DCD_07.09-27
DCD_07.09-27 S01

US-APWR Design Control Document

SAFETY SYSTEM DIGITAL PLATFORM -MELTAC-

MELTAC Platform ISG-04 Conformance Analysis

Figure H.1 Configuration on Control Network

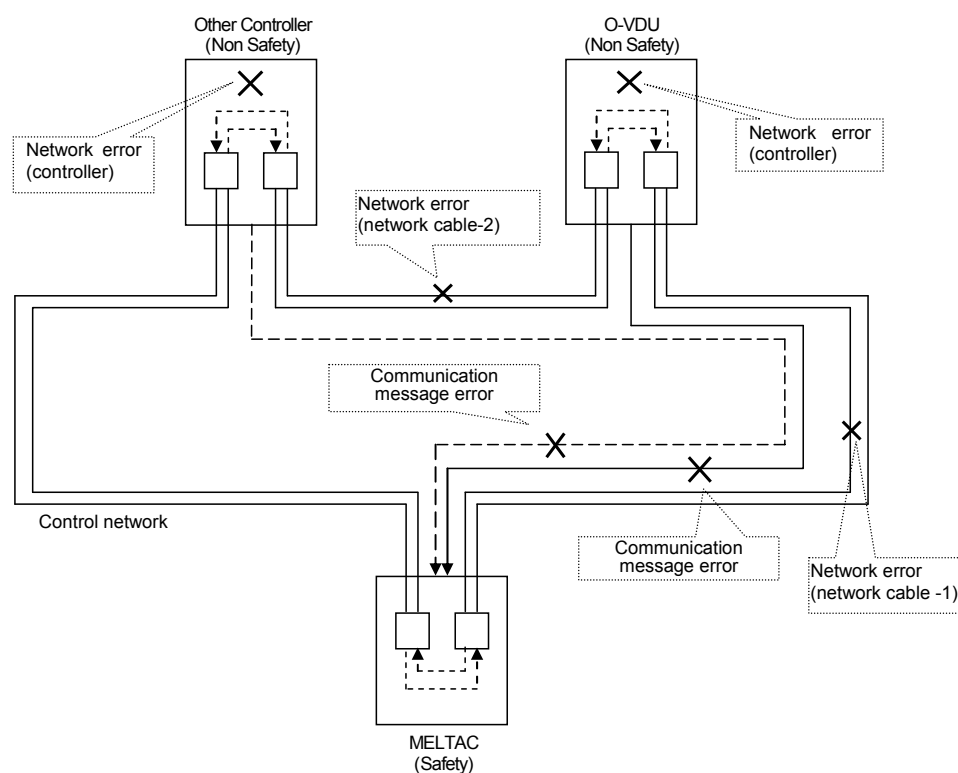
If a cable between controllers (e.g., ~~the~~ network cable-1 in Fig.H.1) is disconnected, this will not affect a cable between other controllers (~~the~~ e.g., network cable-2 in Fig.H.1).

Figure 4.2-2 Electrical Independence Features between PCMS and PSMS

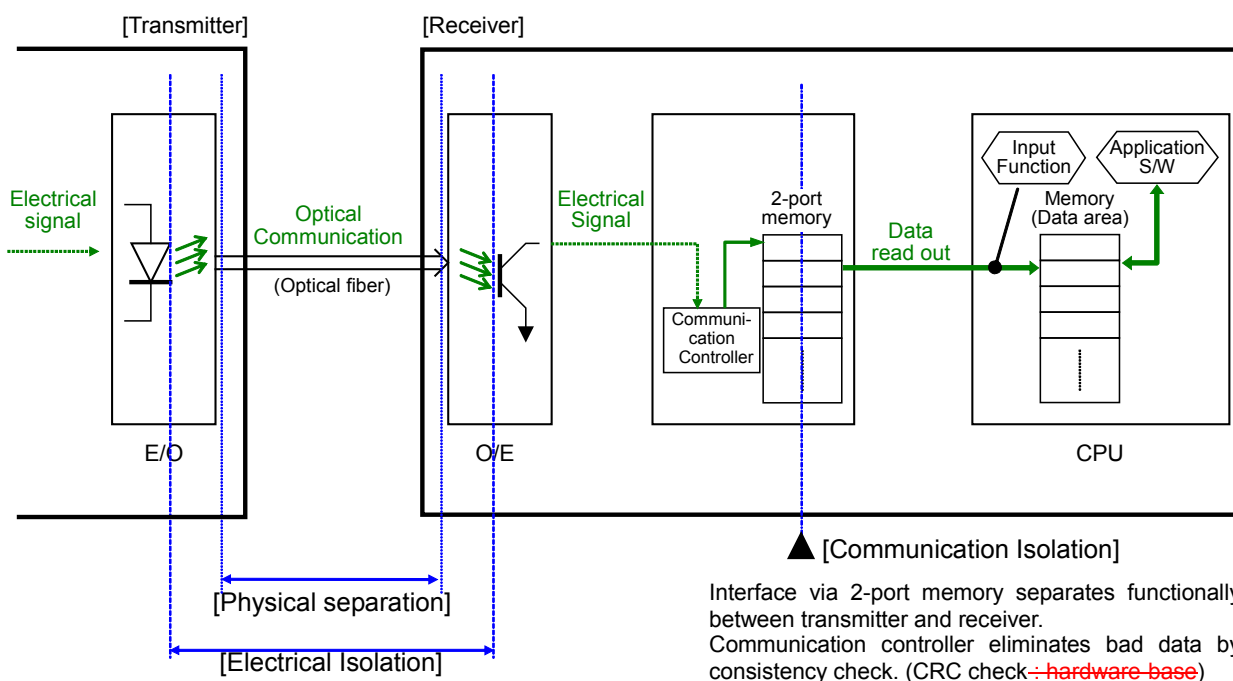
DCD_07.09-27 S01

DCD_07.
09-27
S01

Figure 5.1-1 Signal Interface of Output Module

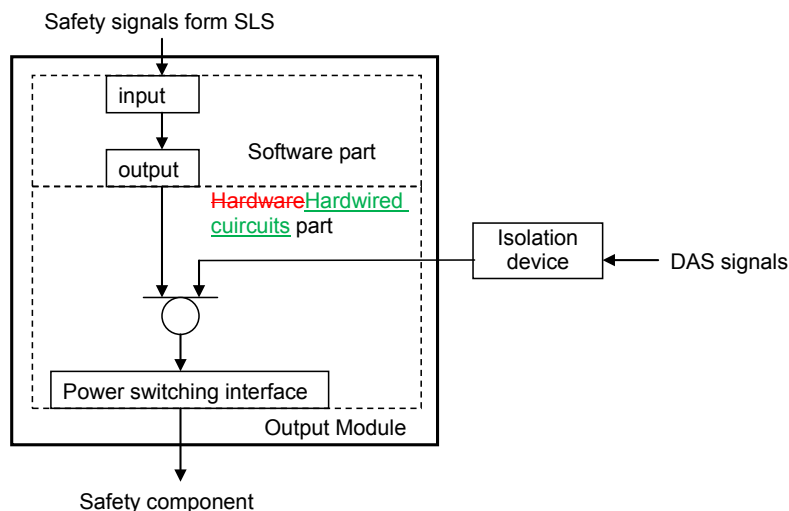
DCD_07.
09-27
S01
